ADDENDUM DESIGN STATEMENT

Change of Use to Upper Floors and Alterations
to create 46 Bedroom Hotel

1-3 York Street, Manchester

Fig 9: Extract from bedroom detail drawing at second floor level showing extent of ceiling raft in main bedroom area.

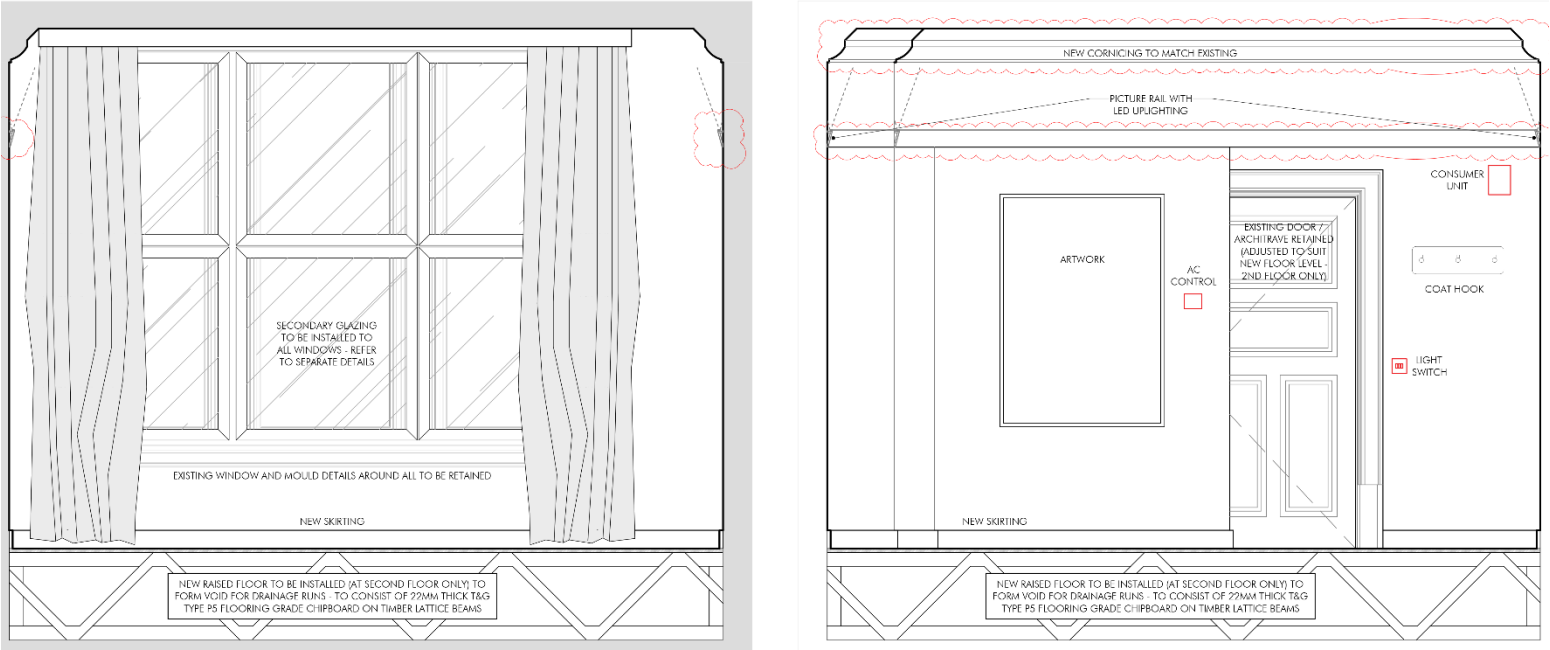
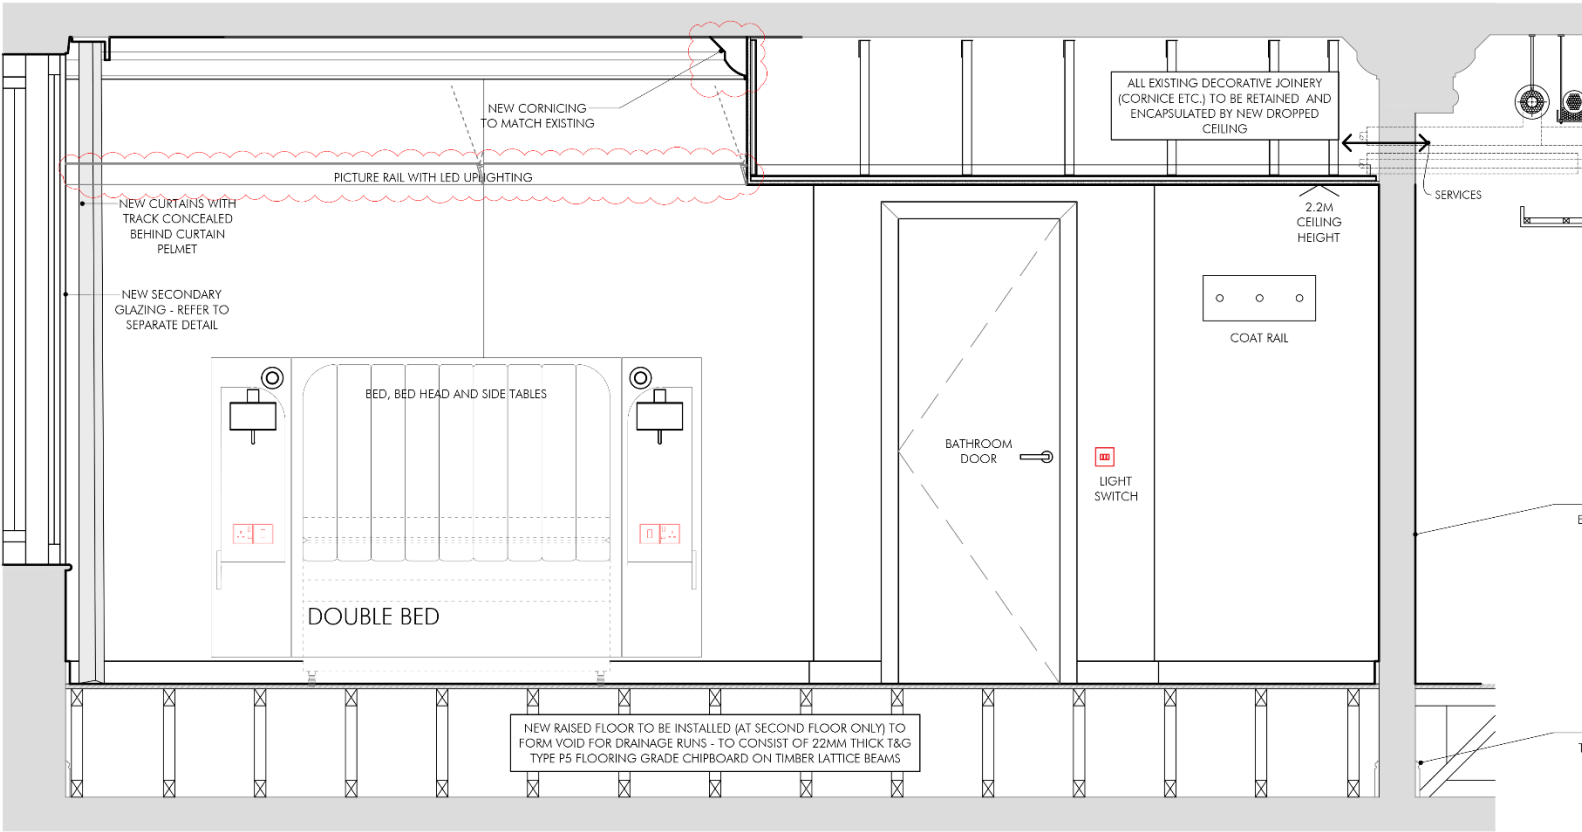
1.05	An additional cross-section/reflective ceiling plan should show the scope/location of the dropped ceilings to bedrooms. Concerned about the bulkhead width in relation to external windows – see cross-section B-B for example. Dropped ceilings & services should be the very minimum required and evidenced as such (see above).	Typical drawing AP21/D shows the scope and detail for the bedroom ceilings, which has been amended to a more minimal raft. Each room shall have a bulkhead at the corridor end of the room to allow service to enter below cornice level and to house at air conditioning unit for each room. A 3-dimensional illustration of a couple of room examples have also been included and added to the Addendum Design Statement section 1.3 The two small areas of bulkheads within bedrooms 201 & 202 that are visible on cross-section B-B only occur in a limited area due to the re-routing of services to allow the initial section of corridor to be fully restored without a ceiling raft in place. This gives precedence to the public experience of the corridor (immediately off reception) over the private experience of those rooms. A detailed account of this proposal is given in section 1.2 of the Addendum Design Statement.	1.3 1.2 Drawing ref: AP21/D

1.19	More information is required to show services/rafts/dropped ceilings in bedrooms across the listed building.	Typical drawing AP21/D shows the scope and detail for the bedroom ceilings, which has been amended to a more minimal raft. Each room shall have a bulkhead at the corridor end of the room to allow service to enter below cornice level and to house air conditioning unit for each room. A 3-dimensional illustration of a couple of room examples have also been included and added to the Addendum Design Statement section 1.3	1.3 Drawing ref: AP21/D

The proposed building sections have been updated to show in greater detail the extent and impact of dropped ceilings in bedrooms. The existing floors are solid concrete construction, so there is no floor void to distribute services into the space. To better highlight the existing room volumes, the previously proposed ceiling raft in the main part of the bedroom has been omitted. Instead, the design will enhance the original cornicing with LED picture rails, providing uplighting to celebrate these historic features.

Where services (electrics, water and air conditioning pipework) enter the room adjacent to the corridor, an area of dropped ceiling will need to be provided low enough to allow these services to penetrate and pass through the wall below cornice level. This lower dropped ceiling will be a minimum of 350mm deep, low enough to also conceal a built-in air conditioning cassette unit.

Hot and cold-water services and ventilation ductwork will need to be concealed in this lower ceiling that will also extend over the ensuite shower room where ventilation grilles will terminate.

Fig 11: Top: Previous proposal to provide linen trolley store with removal of 'borrowed light' window at second floor level.

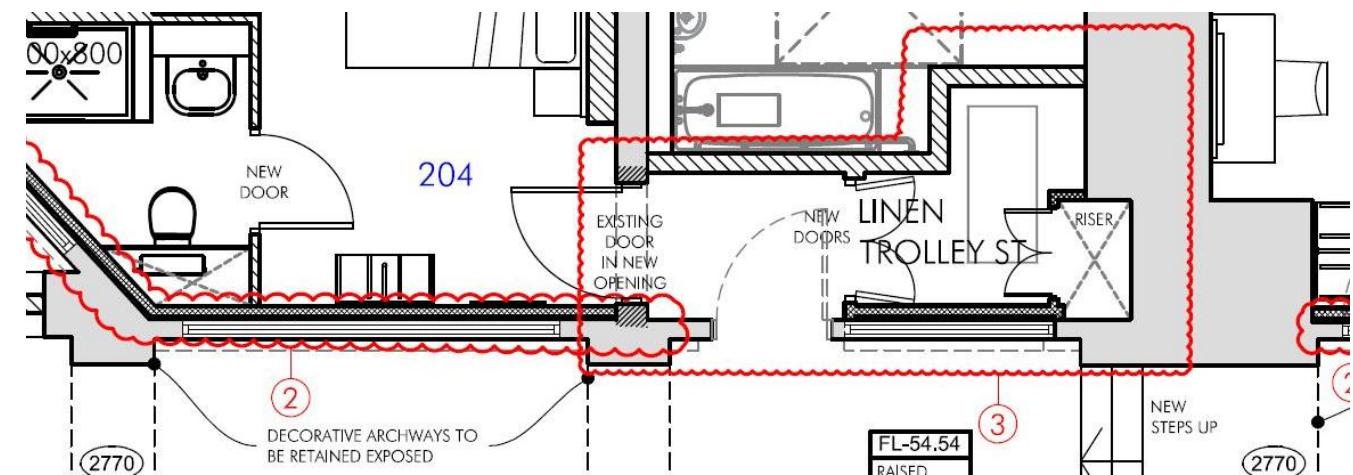
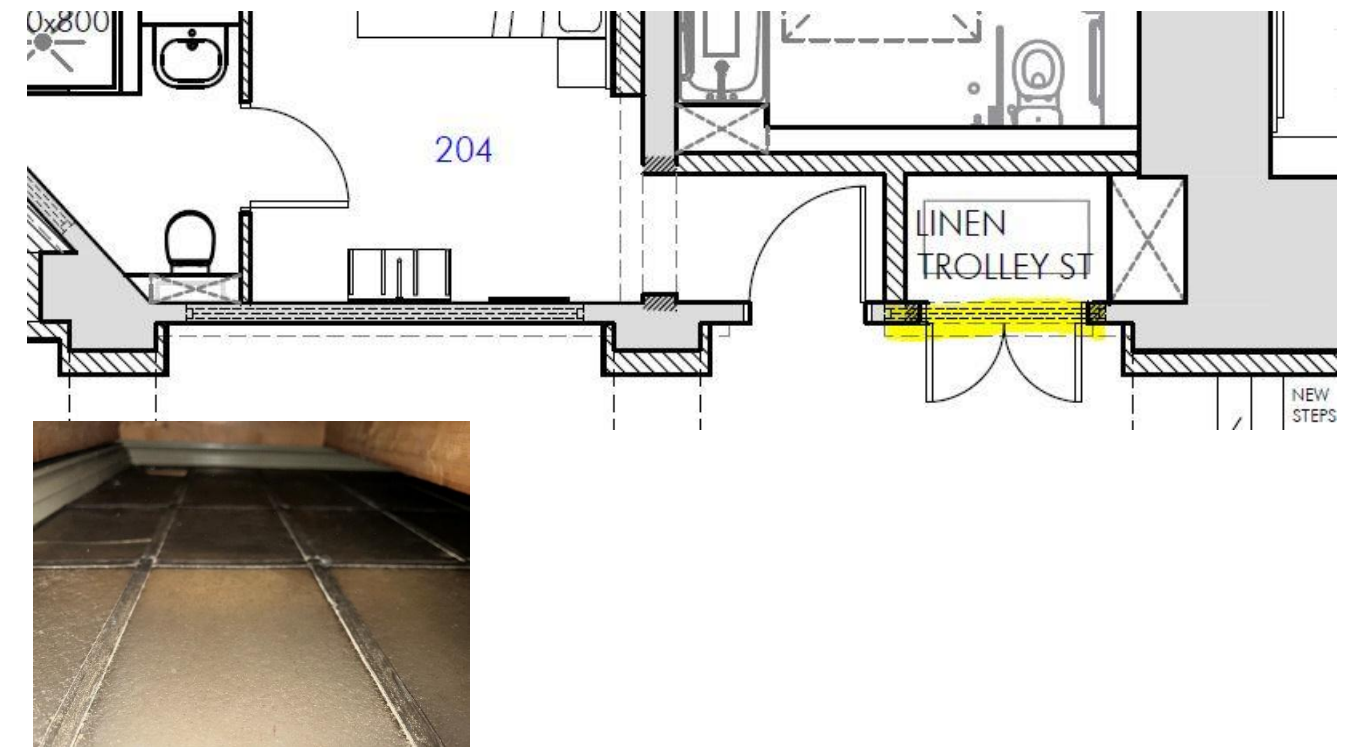
3.0	<u>Floorplans</u>		
3.01	New linen door on second floor – will any original/historic fabric be removed? Photographs required.	As highlighted on existing drawing AS02/A and proposed plan drawing AP02/J this is a previous opening that has been blocked-up in modern brick and blockwork. A photograph has been added to Addendum Design Statement Section 1.4  	1.4

An example of redesign to retain the borrowed light windows is given opposite, where the entrance to a linen trolley store has been relocated to allow the internal window to be exposed on the corridor side.

Bottom: Revised re-design to alter access to linen trolley store to allow for retention of the borrowed light window, to be exposed on the corridor side.

Fig 14: Left: Proposal for room 301 layout. Right: attempt to redesign room 301 to retain corridor borrowed light, highlighting reduced space to room 301. *

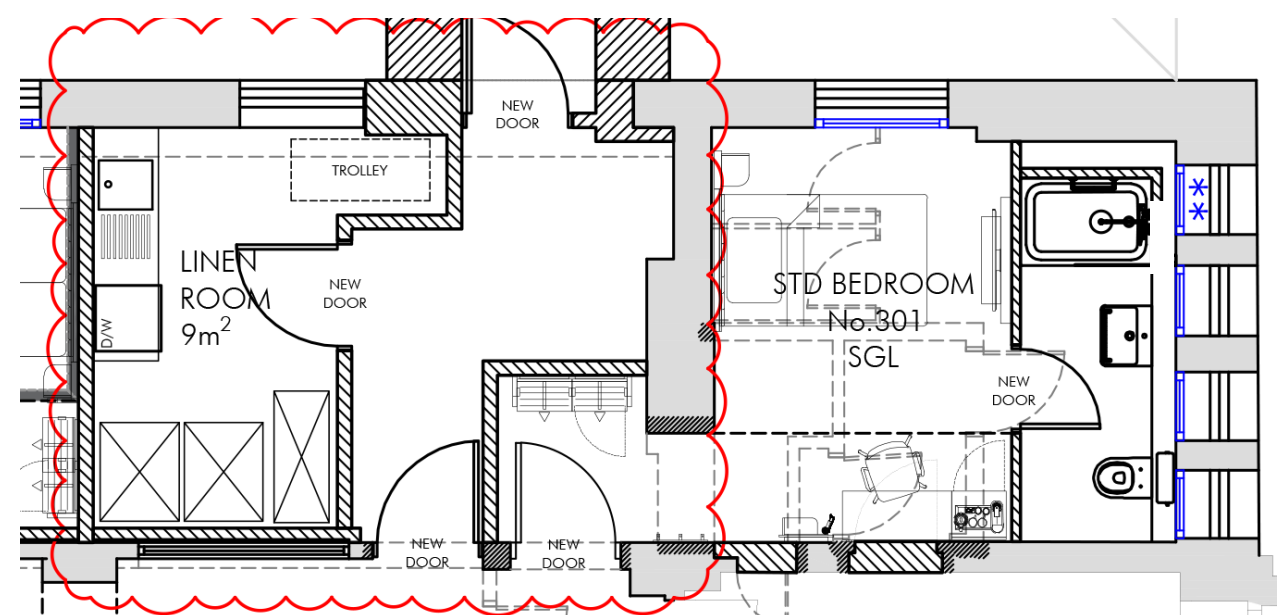
3.06	Reconfigure access to bedrooms (301 and 401) and linen room on third and fourth storeys, to retain borrowed lights and original doors on third floor	At 4th floor (access to room 401 & linen room), there is an existing opening that has been blocked-up in modern brickwork and concrete blocks. This is clearly annotated on existing drawing AS04/A and Proposed drawing AP04/H. A photograph has been added to statement section 1.4:  Access to room 301 & linen store is the only instance in the building of a proposed joinery modification to an existing internal borrowed light window. Full commentary on that decision and detail of mitigation is given in Addendum Design Statement section 1.4	1.4 Drawing refs: AS04/A; AP04/H

The design changes outlined on the previous two pages have allowed the retention and exposure of 'borrowed light' windows in all areas of the building, with only one exception. The drawing extracts, pictured below, show: (left) the proposal to access room 301 and the adjacent linen room, borrowing some space from the linen store to accommodate a bedroom wardrobe, freeing-up space in room 301; and (right) an alternative re-design to avoid a reduction in the borrowed light window hidden in the corridor wall.

Fig 15.1: Photographs showing modern brick and blockwork infill where a previous opening has been filled-in to location of proposed doors to 2nd floor linen store (proposed plan extract on the right).

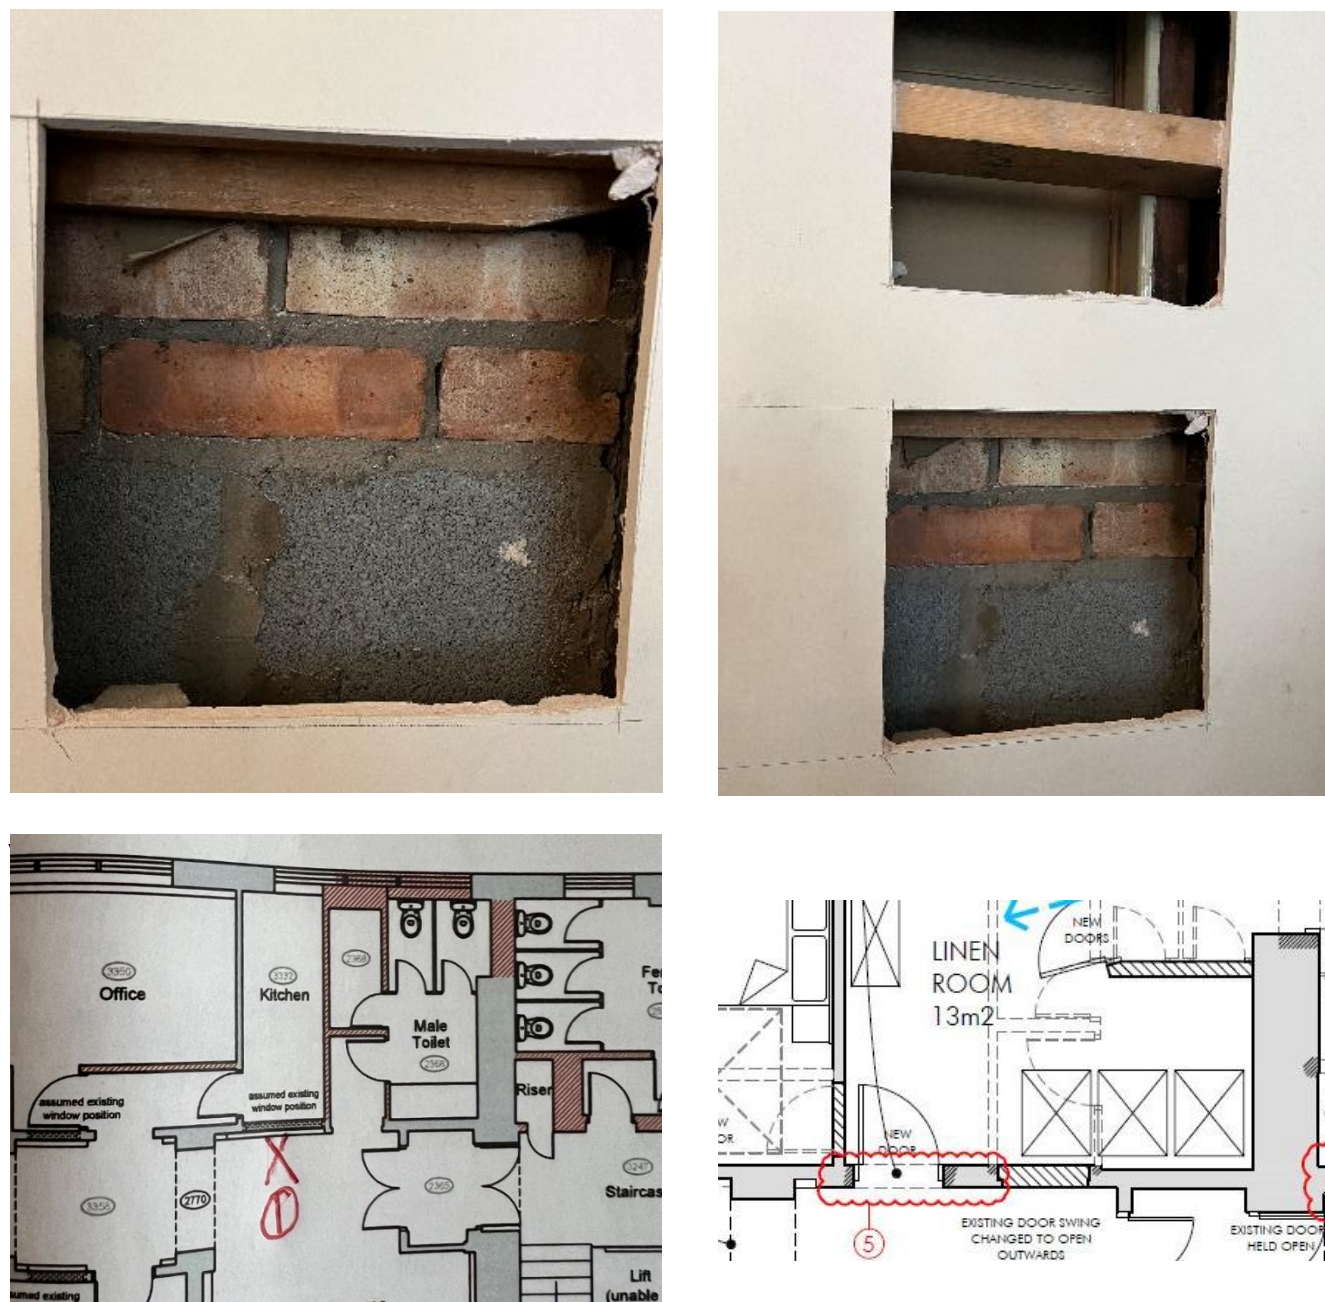
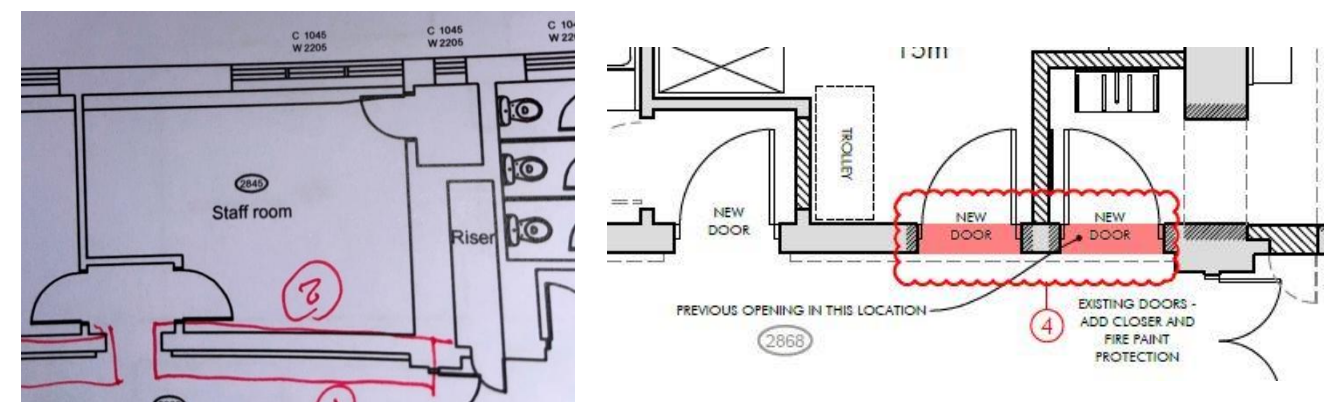
TABLE 2: SUMMARY OF CONSERVATION OFFICER COMMENTS RECEIVED 18/10/2023:			
Item	LPA Request	APP Commentary	Addendum Design Statement Section Ref:
3.02	New entrance to the proposed bedroom 314 will any original/historic fabric be removed? Photographs required.	No historic fabric will be removed other than to form a new doorway. The existing door will be retained in situ, fixed shut, and a stud wall constructed to the inside face to maintain fire and acoustic properties. A note has been added to drawing AP03/H to identify that the existing door is to remain. This Section of corridor does not have any existing wall tiling. Full commentary on why that room is 'handed' as shown and requires a new doorway has now been provided in section 1.4.	1.4

Further photographic evidence has been requested to show the lack of harm caused by new openings at 2nd floor (new linen store doorway) and to 4th floor (room 401 & linen store doorways). This is provided below:

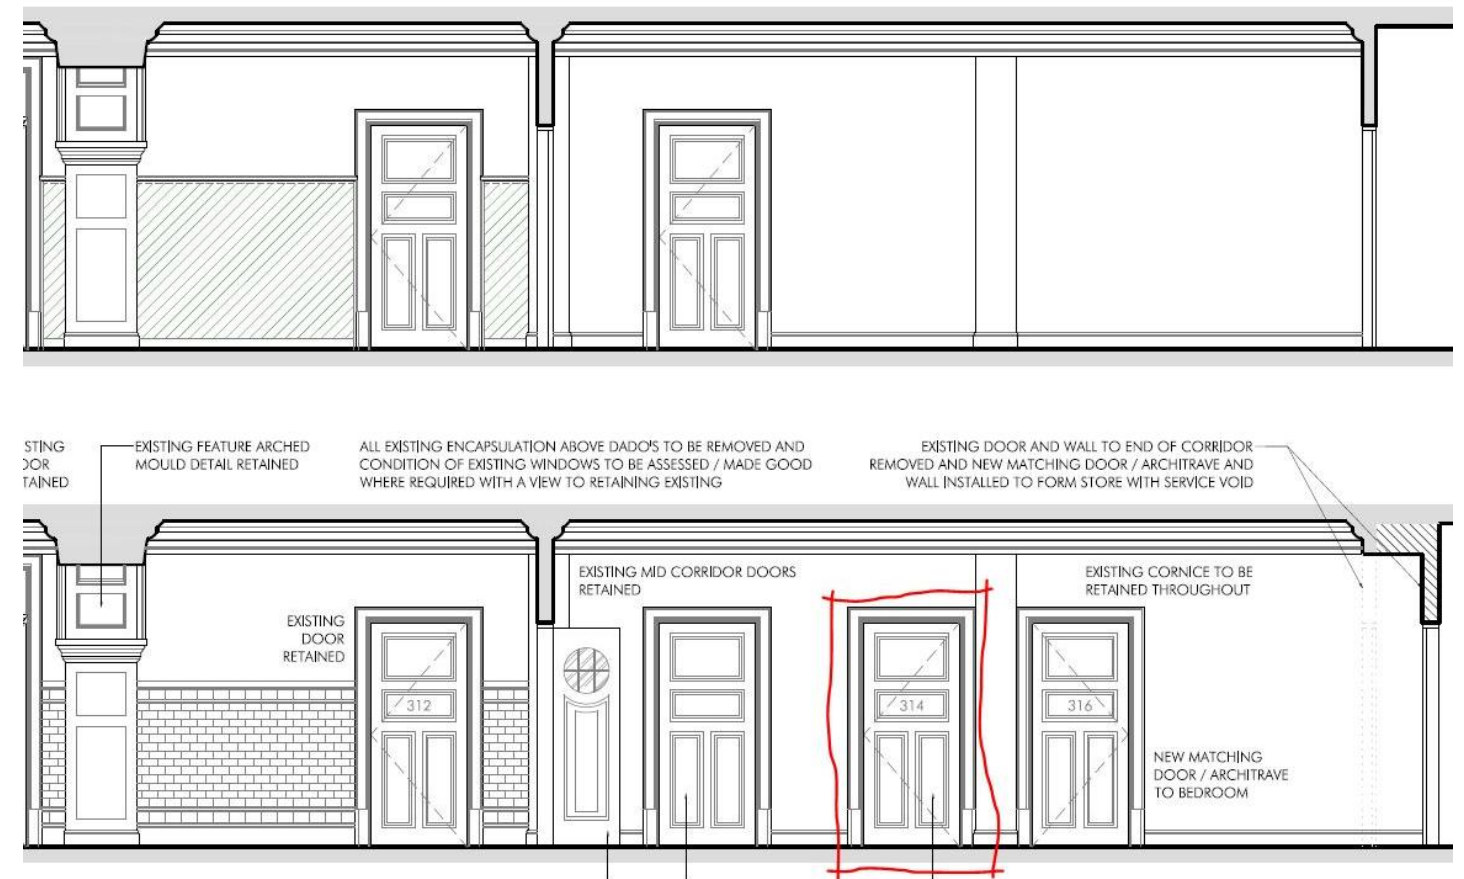
TABLE 2: SUMMARY OF CONSERVATION OFFICER COMMENTS RECEIVED 18/10/2023:			
Item	LPA Request	APP Commentary	Addendum Design Statement Section Ref:
3.05	Retain existing door to room 314	This has been noted as to be retain on revised drawing AP03/H, albeit fixed shut. The need for an alternative door entry to room 314 is expanded on in section 1.4 (see also point 3.02 above)	1.4 Drawing ref: AP03/H

From the floor plans it is evident that the rooms above and below 314 have the same 'hand' of layout. This determines the bathroom position and the bedroom layout. The bathrooms require vertical drainage services, and also central ventilation extraction is routed to the bathroom side. If the handing was switched on 3rd floor, boxing in would be required within the rooms for these vertical services, plus additional vertical services for the new bathroom position would be required and similarly require boxing-in on 2nd floor. Weighing up the resultant harm, we have selected a design of least harm to the existing building fabric. The door to 314 is to remain in place, shut and boarded on the bathroom side, thus no original fabric is removed. In the corridor outside room 314, there is no wall tiling that would be damaged by the insertion of a new door. As can be seen on the illustration below, a new matching door for room 314 (and also for room 316) will be inserted into the existing wall with no damage or removal of tiling features.
